Letter of Objection to the development at Former Tower Car Sales, Tower Close, East Grinstead, West Sussex (now known as Whittaker House, 1 Leppard Walk) and retrospective application DM/26/0432

The promotional material (same images as submitted plans); the current front of the building;

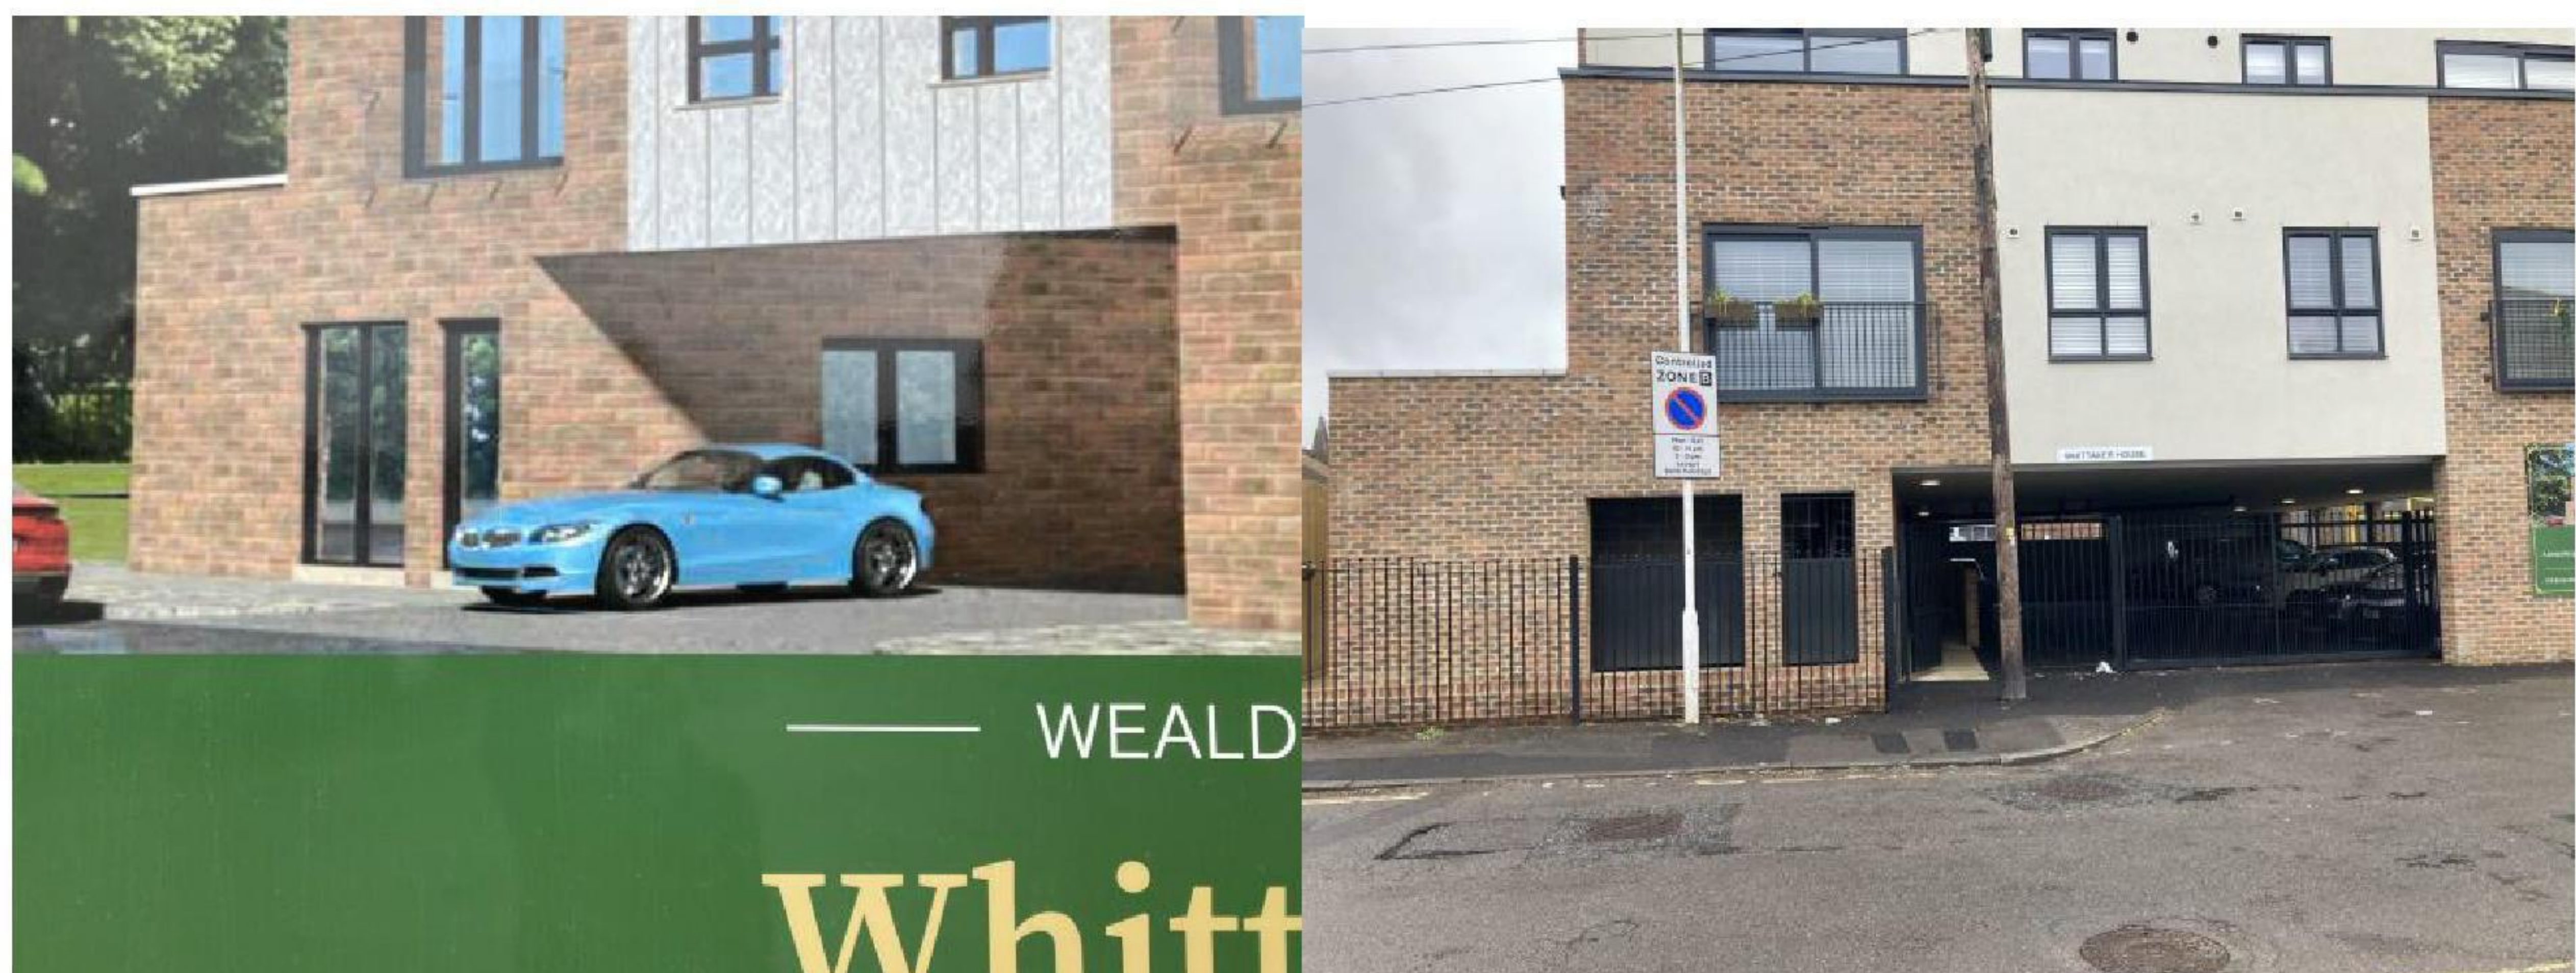
Starting with the outside of the property, Whittaker House was supposed to have a separate entrance, with a wide gated walkway to the right leading to a dedicated bike storage for 10 bikes, and 2 large refuse bins (sufficient bin storage for 8 properties). Both of these areas would lead into the entrance hallway, with the stairwell benefitting from opaque glass and entry into the undercroft.

Planning permission was granted with acknowledgement of this, and noting that resident would not have to enter through the undercroft:

The entrance is now our 'dedicated bin and bike storage'. These are so unsuitable for the purpose as to be functionally useless. They remain unfinished, with unfinished brickwork (and bin storage) now forming part of the view for our neighbours. The bin storage area holds 8 bins, with the 9th squeezed in. Our recycling bins now live in the undercroft, as

Dedicated bin storage; Dedicated secure storage for 10 bikes

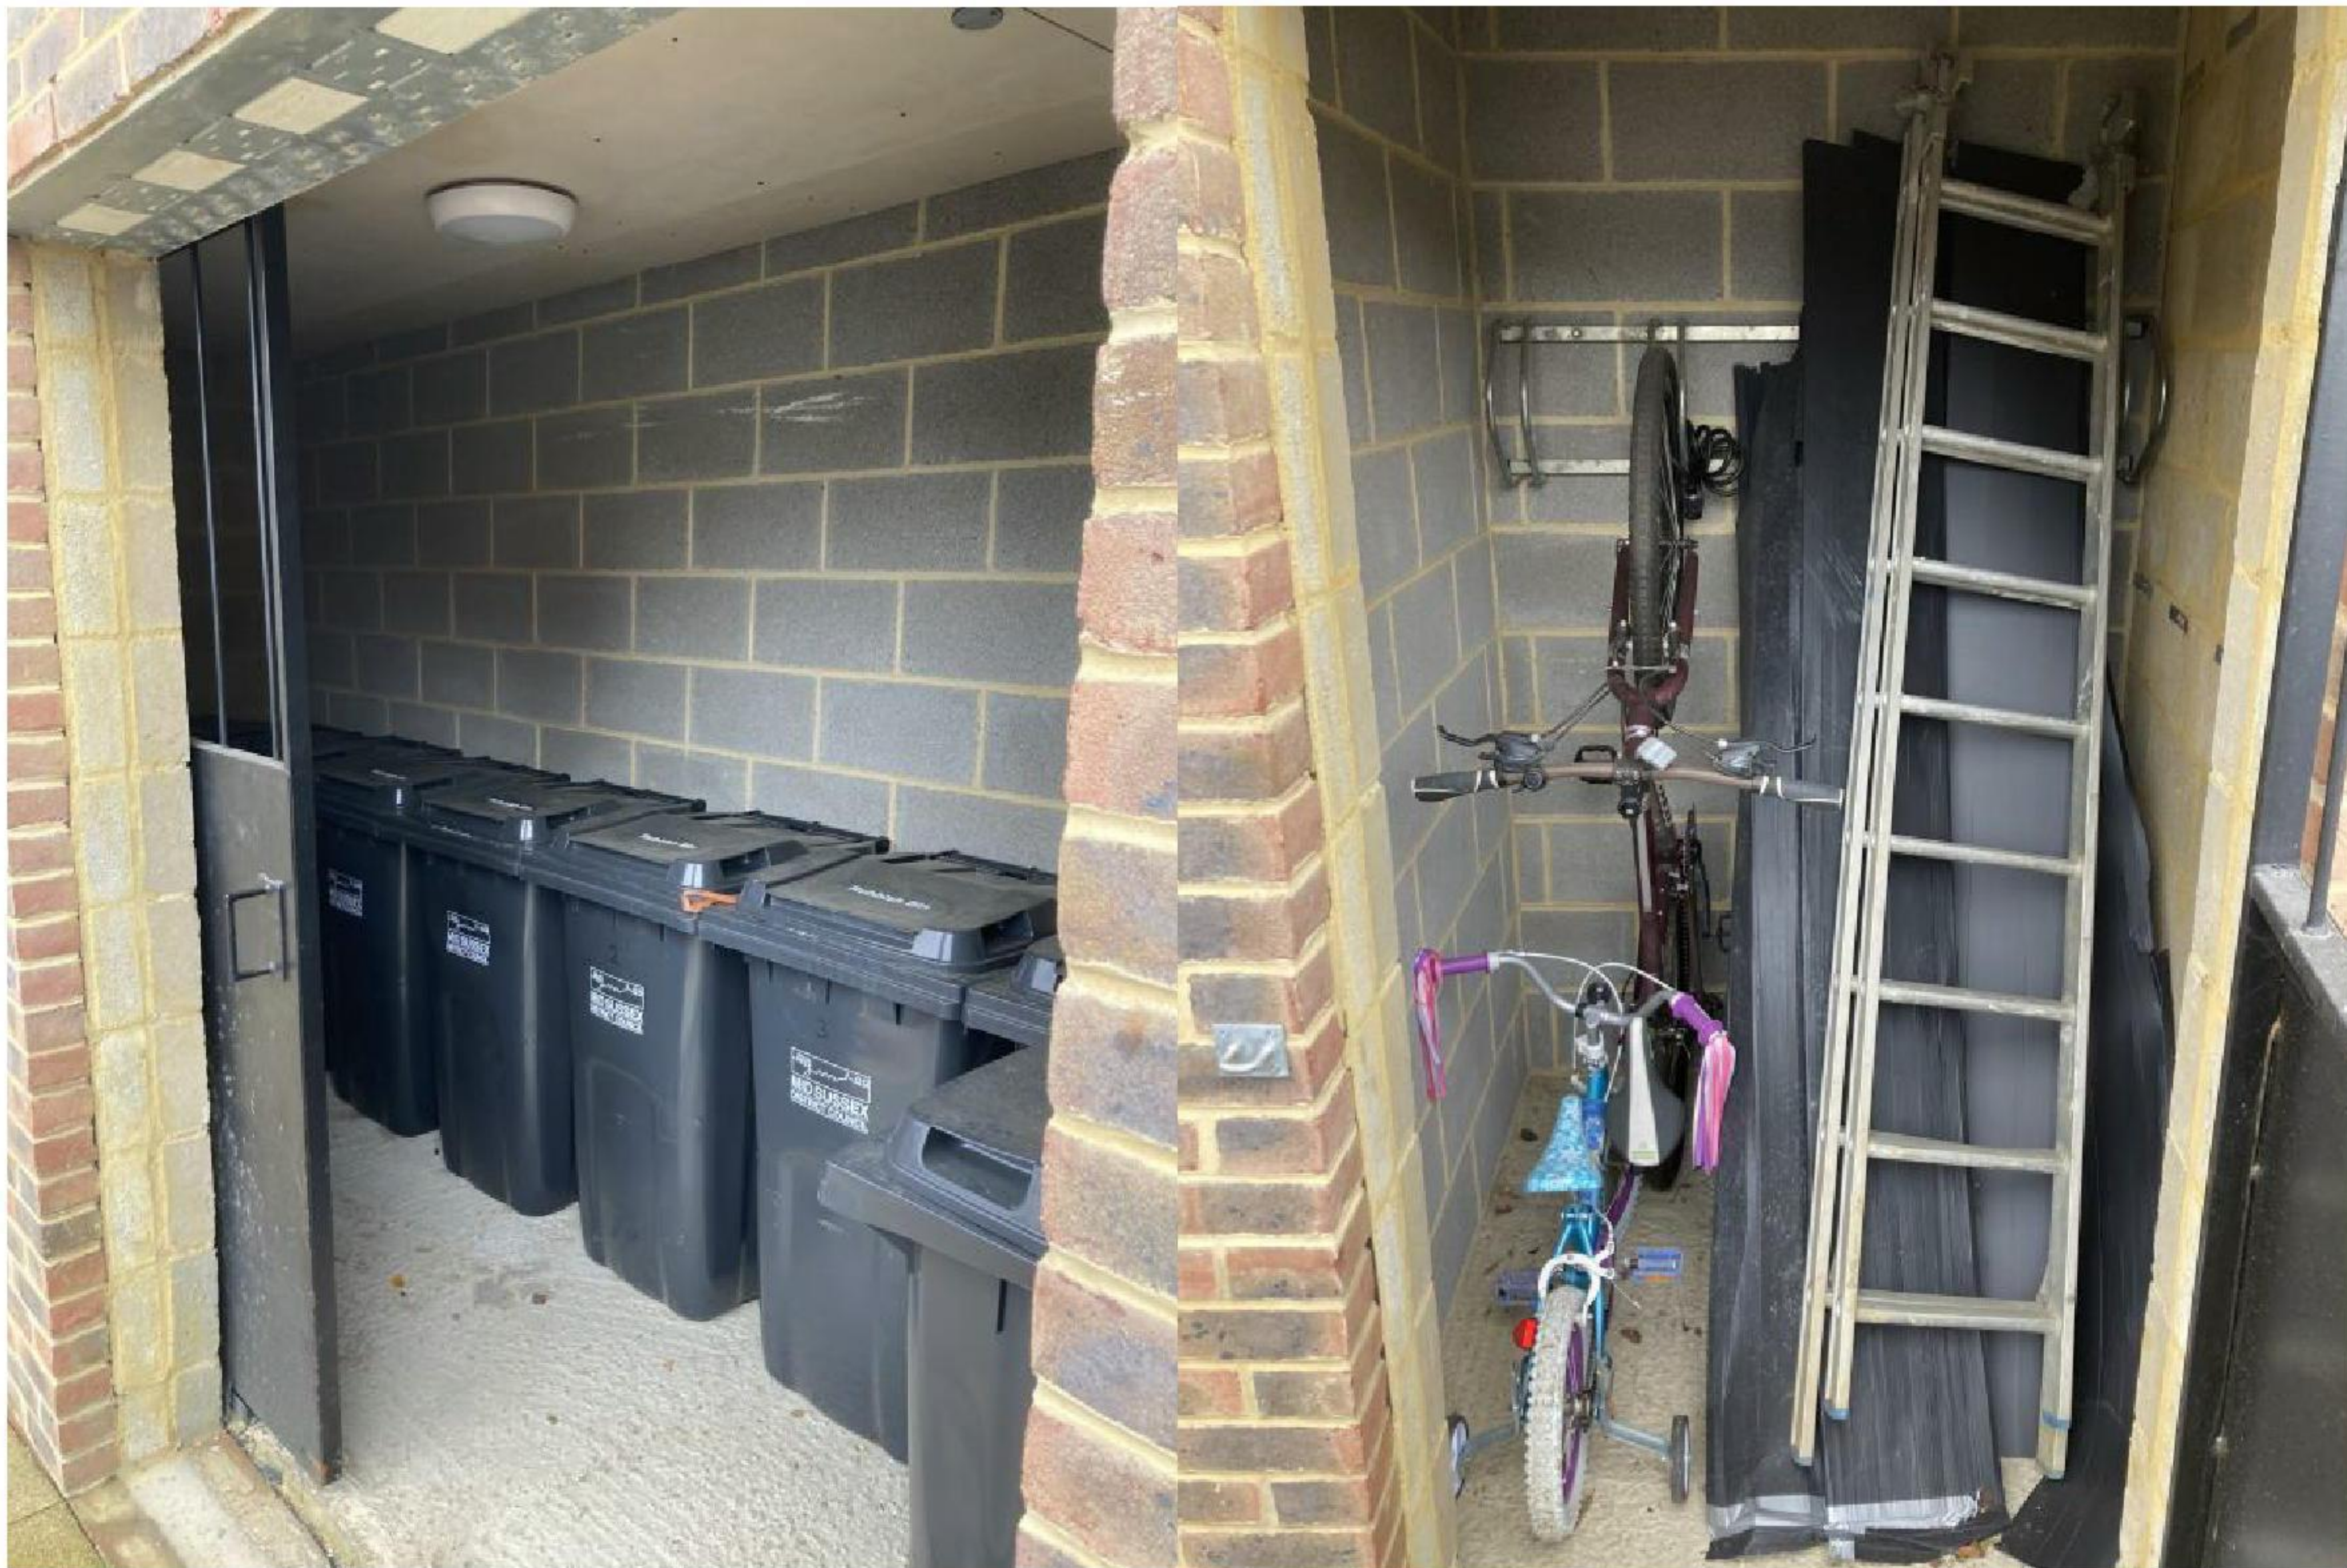
there is no 'dedicated bin storage'. The 'dedicated bike storage for 10 bikes' is honestly my favourite part of the development:

It would be funny if the property hadn't been marketed and sold as having dedicated secure bike storage, if said storage wasn't also mentioned when granting planning permission, and if several of the current freeholders hadn't purchased their property with this specific feature in mind.

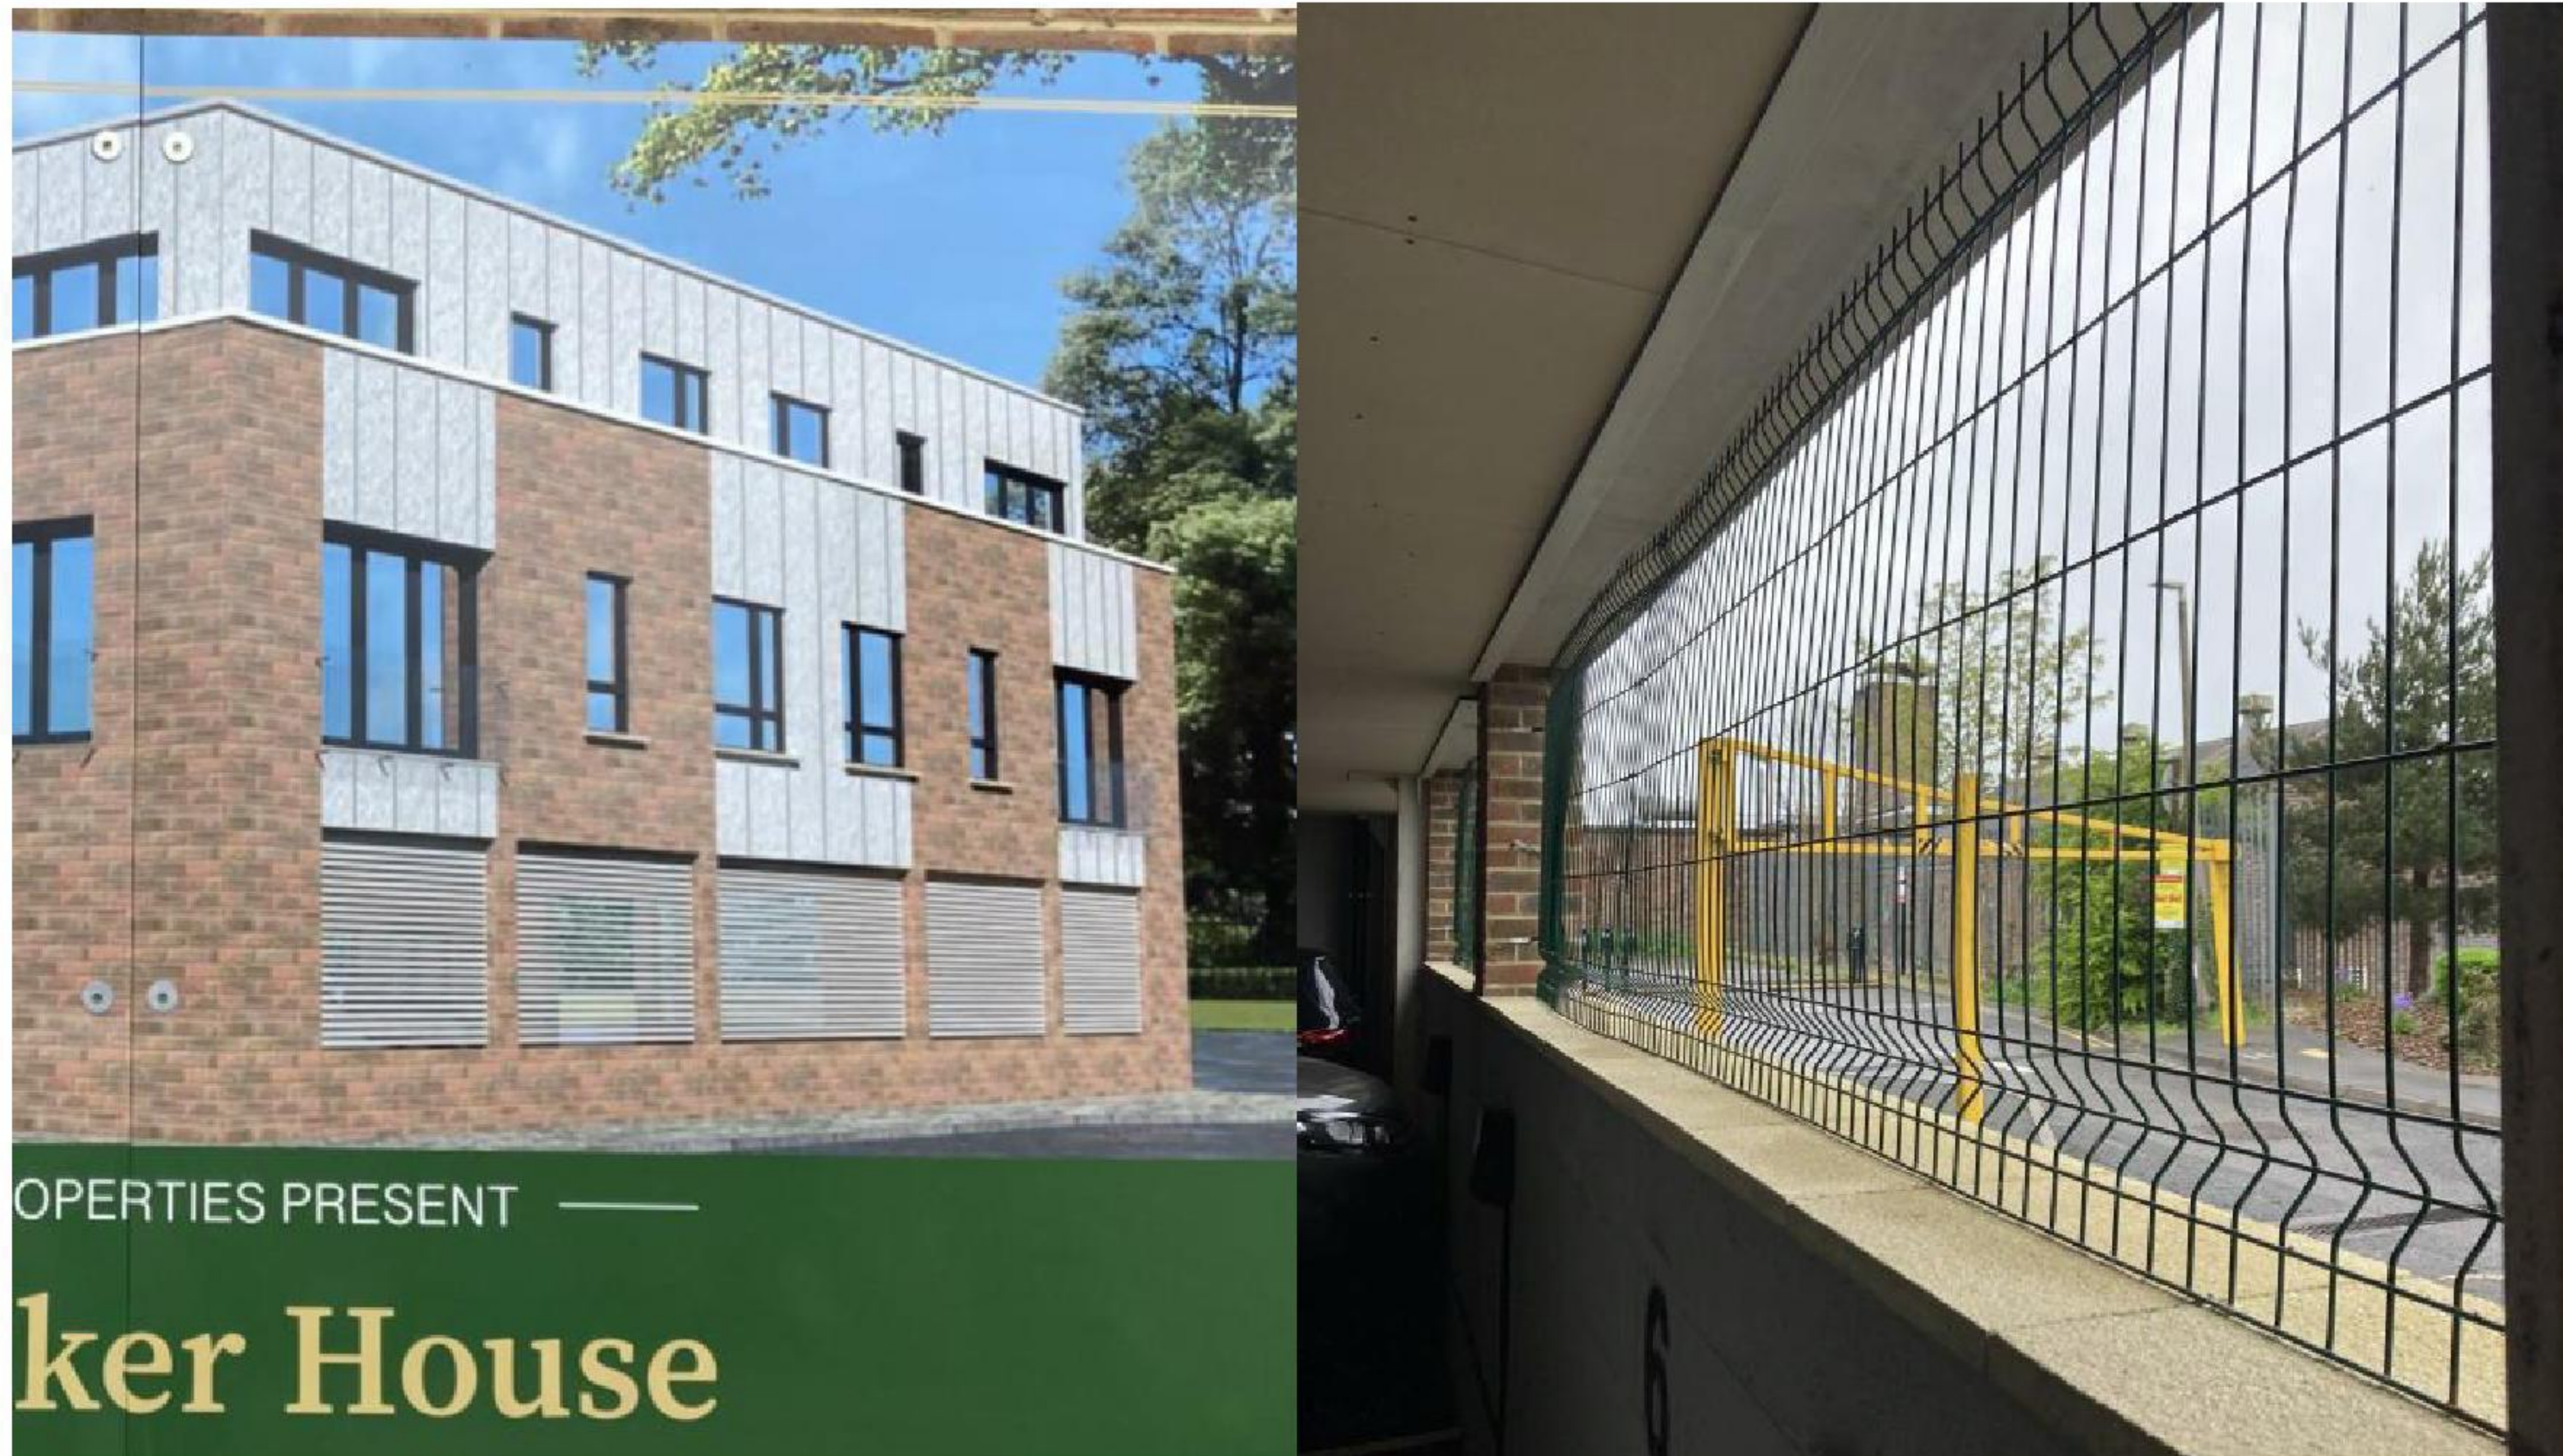
Planning permission for Whittaker House was granted on the expectation that residents would not need to enter through the undercroft, and they would have a dedicated entrance. This has also been sacrificed to make room for a potential 10th flat, with the entrance now located within the undercroft. None of the entry systems, neither internal nor external, have ever worked. The developer has been reached out to numerous times to correct this, but as of writing, no one in Whittaker House is able to receive guests, or secure deliveries, without either getting telephoned first or waiting outside the property. This is yet again more proof of the developers lack of character, and the disparity between what both we and the Planning Office were sold versus what was delivered.

The opaque glass has now been replaced with a back door, which accesses the bin and bike storage and takes us past Flat 1A's front door. The area under the stairs, which was supposed to be our hallway through to a front door, is now the cupboard where all our meters are stored. Further proof that the developer had no intention of building to plan, permission, or sales materials:
